PAULINS KILL DAM

NJ 00274

PHASE 1 INSPECTION REPORT^C NATIONAL DAM SAFETY PROGRAM

PHASE I INSPECTION REPORT
NATIONAL DAM SAFETY PROGRAM

Deteriorated Footbridge planks and
detached railing.

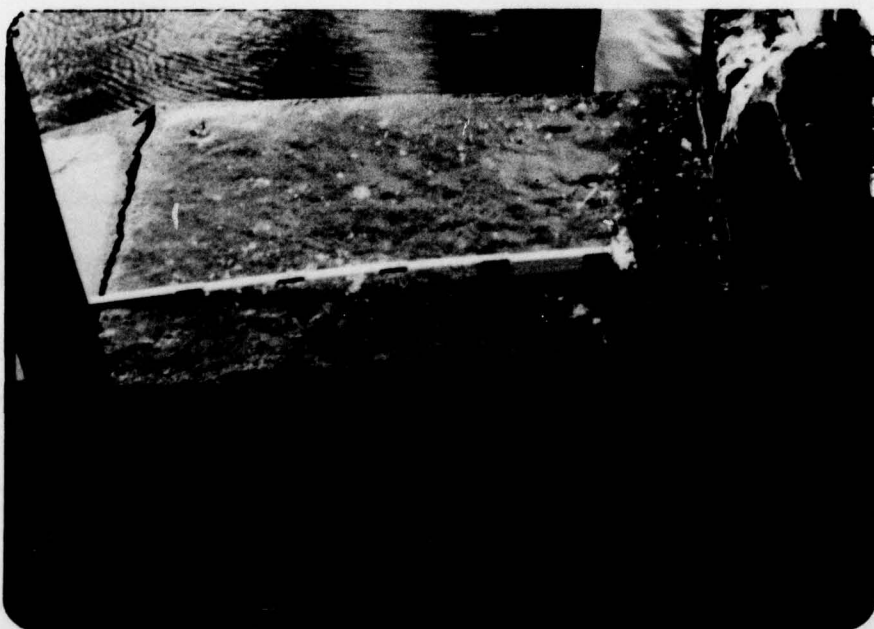
9. The footbridge provides access for operation of the low level outlet should be strengthened to ensure continued access to the gate operator stand. This should be done soon.
